Staff Report

Meeting Date: June 9, 2022 (Prepared June 2, 2022)

Item: 2540 & 2600 Newberg Hwy, "US Market" gas station (CU 21-02)

Action on a consolidated land use application package (Type III), Conditional Use 21-02, Design Review 21-10, Exception to Street Right of Way and Improvement Requirements ("Street Exception") EXCP 21-05, & Phasing Plan PP 21-01 for a gas station with convenience store, known as US Market, and commercial office space, in the Commercial General (CG) zoning district.

Exhibit PP1: Option 1 Site Plan Excerpt Prior to Revision per Conditions of Approval

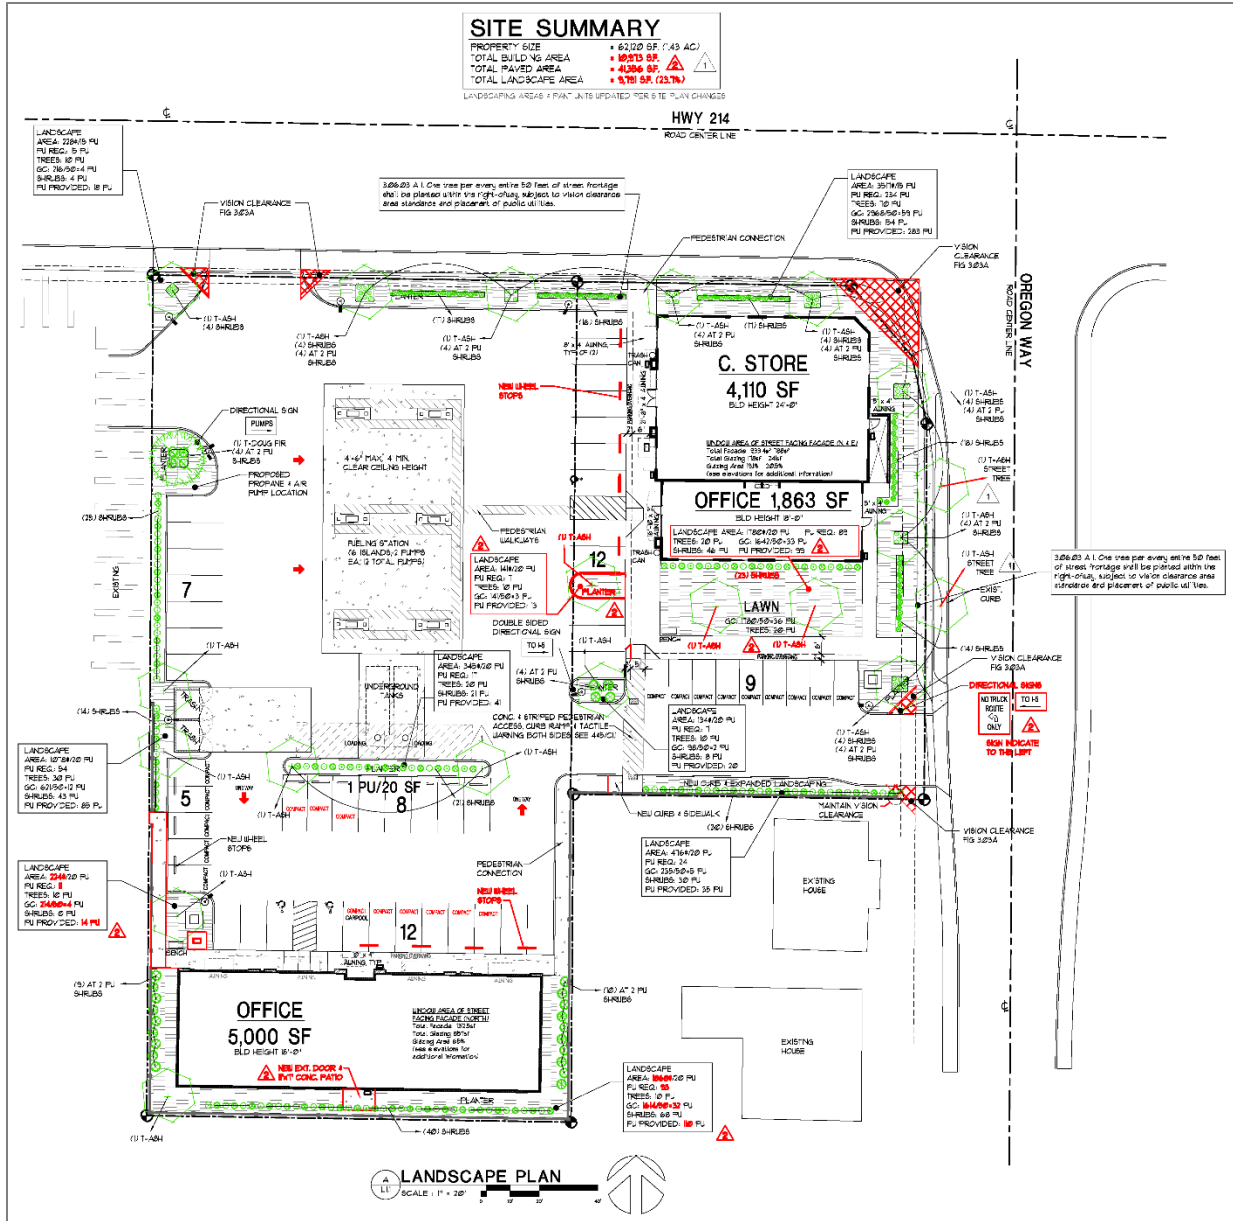
1. Options 1 & 2: The developer may develop a site plan revised to conform to conditions of approval and based on either:
 - a. Option 1: The site plan concept last revised and re-submitted for land use review on February 9, 2022 and premised on there being no ODOT factor (see the ODOT factor condition); or

2. Basic Descriptions:
 - a. Option 1: See Exhibit PP1 below for plan details.
 - (1) On Tax Lot 3600 (east, corner lot), a single northeast building of with convenience store of 4,110 sq ft and a commercial office of 1,863 sq ft.

- (2) On Tax Lot 3700 (west, interior lot), a north fuel pump canopy and a south commercial office building of 5,000 sq ft.
 - b. Option 2: See Exhibit PP2 below for plan details.

5. By and as part of building permit application, the applicant shall submit revised site plans meeting the conditions of approval.

Exhibit PP2: Option 2 Site Plan Excerpt Prior to Revision per Conditions of Approval

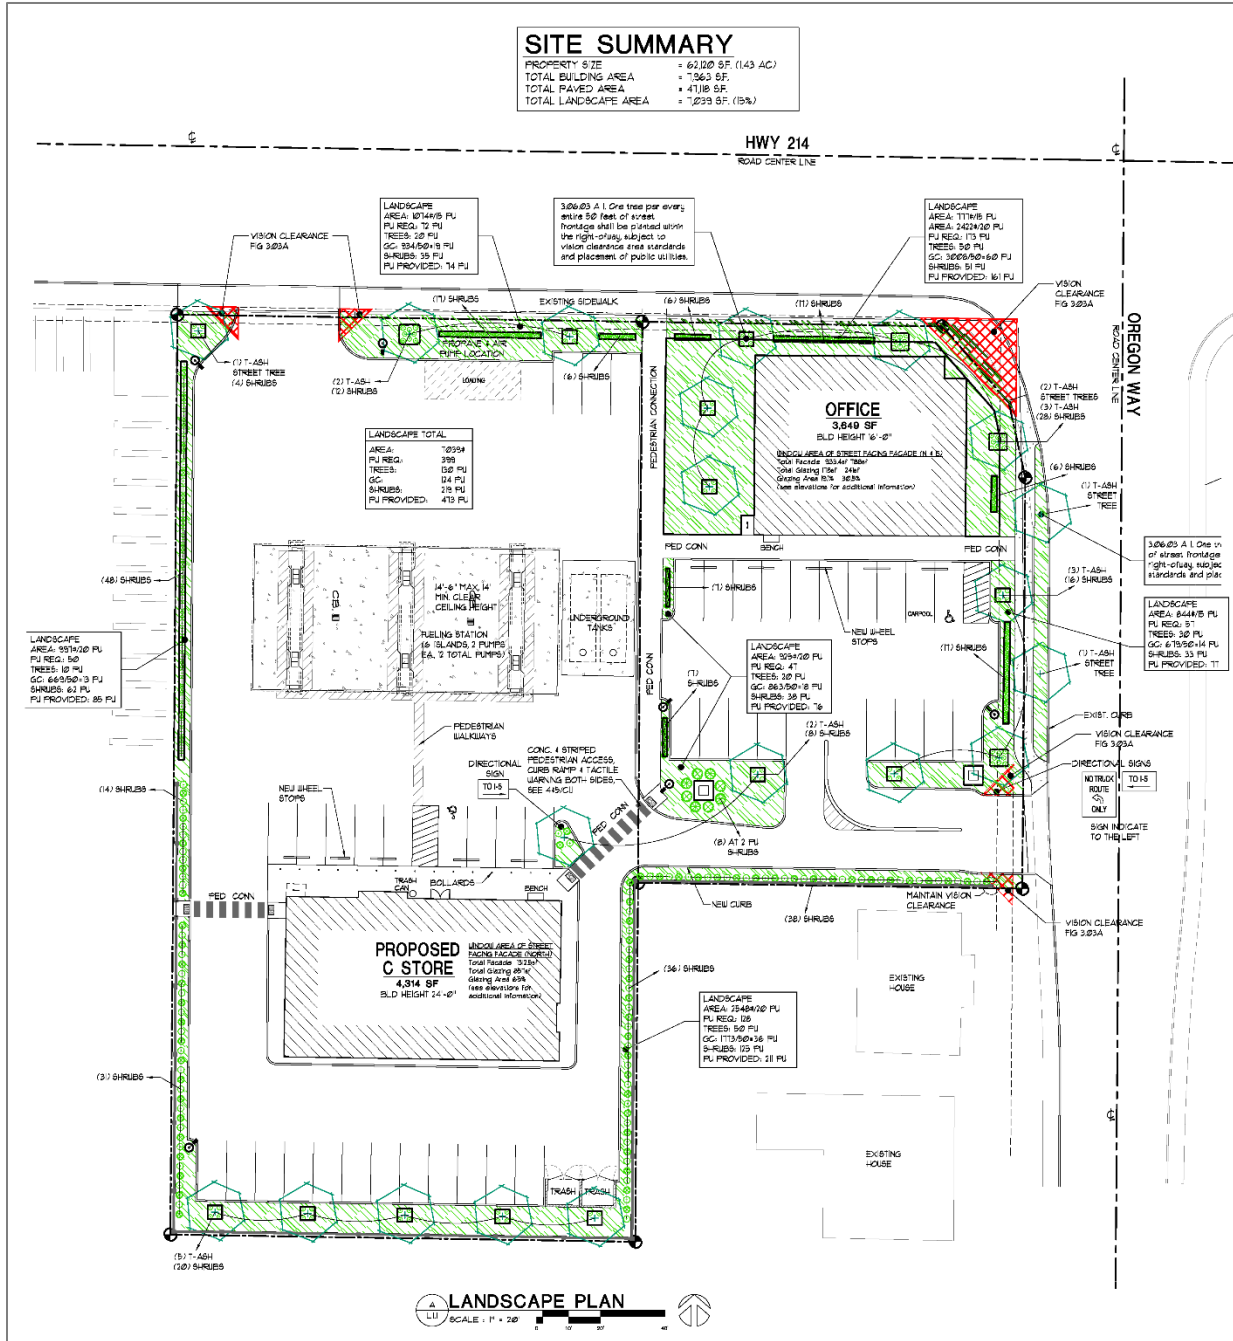
- b. Option 2: The different site plan revised and submitted May 2, 2022 premised on the developer's understanding of the ODOT factor.
This due by building permit application.

D2. Parking / vehicular circulation setback: Option 2: To conform to WDO 3.05.02E, the developer shall do one of the following: (a) revise the site plan to set back parking and vehicular circulation area min 5 ft from the northerly east lot line of 2600 Newberg Hwy (Tax Lot 3700) and to landscape the setback per 3.06 and plant min 4 trees within it; (b) have a shared use agreement per 3.05.02E; or (c) doing (a) in part and in combination with (b). This is due by building permit issuance.

Exhibit CU2f (DR 2017-08)

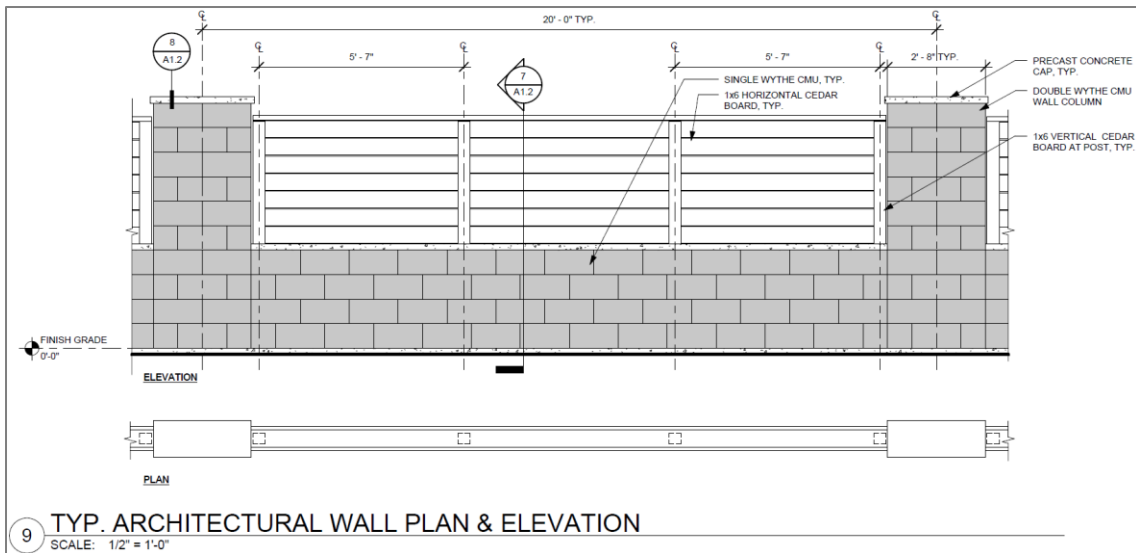
- e. Color: Masonry and any paint shall be a color or colors other than black, charcoal, or gray. For any other fence / fencing or free-standing wall, including gates if any, the coating and slats that WDO 2.06.02D requires and any wall shall be a color or colors other than black or charcoal. On free-standing walls with two or more colors, darker colors shall be towards the bottom and lighter ones towards the top.

- f. Material: AW segments at 40 ft north or farther from the south lot line of Tax Lot 3700 may be partly made of opaque cedar wood fencing if the wall remains mostly masonry. Specifically, masonry must constitute the bottom extent of wall segment from grade up to min 2 ft, 8 inches above grade, and there shall be piers or pilasters per “Details” below. Exhibit CU2f below illustrates a similar, conforming example:

- g. Details: Each AW segment end shall have a pier or pilaster min 16 inches wide relative to wall face and projecting min 4 inches. Each segment shall have a min number of piers or pilasters equal to a ratio of 1 per 40 ft of wall. Each pier or pilaster shall be capped with ornamental concrete in the form of any of a shallow-sloped pyramid or sphere or other finial atop such pyramid. If the AW is CMU, the 8th and 9th CMU courses above grade shall be ground face (5 ft, 4 inches through 6 ft above grade).

Top: Figure 3.01B – Major Arterial (Oregon Hwy 214 / Newberg Hwy)

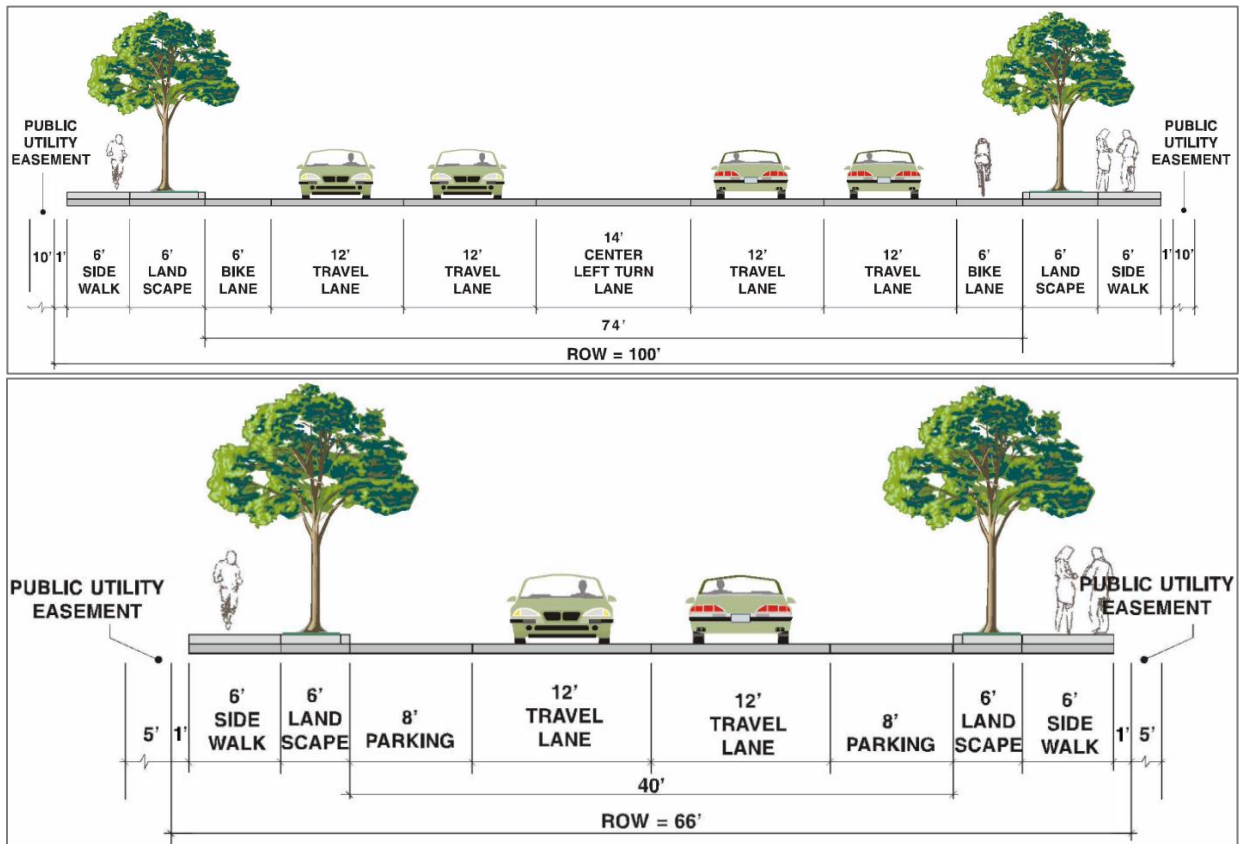
Relative to Figure 3.01B, highway non-conformance is limited to lack of planter strip and street trees. Conventional traffic engineering does not address effects of development on walking and cycling as it does for vehicular trips, there is no widely recognized norm for how to address such, and the WDO provides no guidance on the topic. Second, the north frontage context is strip commercial along a heavily trafficked state highway, the kind of dangerous and noisy environment that repels pedestrian and cyclists. Those who do walk and cycle are likely those who are living nearby, the homeless, those without access to car, and those few who wish to brave existing conditions. The presence of a sidewalk is sufficient for sheer practicality for those who wish to walk along a highway or cycle outside of the bicycle lane because they don't feel safe in a highway bicycle lane. In this context, the number of pedestrians and off-street cyclists is moot. Pedestrians and cautious cyclists can and do use the wide sidewalk today, and the pedestrians and cautious cyclists the development might attract would use the same wide sidewalk.

Relative to Figure 3.01E, Oregon Way non-conformance is limited to lack of parking lane, planter strip, and street trees. Staff applies conditions that excepts only the parking lane but also requires fee in lieu of such parking. Additionally, the conditions require wider planter strip and wider sidewalk exceeding the minimums of Figure 3.01E. Like conventional development

- a. ROW: If and where there is a deficit, the developer shall dedicate ROW that meets or exceeds the min width necessary to conform to WDO Figure 3.01B “Major Arterial”.
- b. PUE: If minimum width streetside PUE does not yet exist per WDO Figure 3.01B, then the developer shall grant it. Max width shall be 10 ft, unless if and where existing utilities that the developer does not relocate necessitate wider as documented by franchise utilities and the developer.
- c. Improvements: No min surface improvements other than either elsewhere conditioned or necessary to comply with ODOT engineering guidance or conform to PW direction. The developer shall pay fees in lieu of highway improvements per Attachment 203.

- a. ROW: The developer shall dedicate ROW that meets or exceeds the min width necessary to conform to WDO Figure 3.01E “Access Street” and exceeds that width where necessary to accommodate both the existing northbound left turn lane and required half-street improvements.

- c. Improvements:
 - (1) Parking: No 8-ft wide on-street parallel parking lane is required, this being an exception from what Figure 3.01E would have required. The developer shall pay a fee in-lieu per Attachment 203.
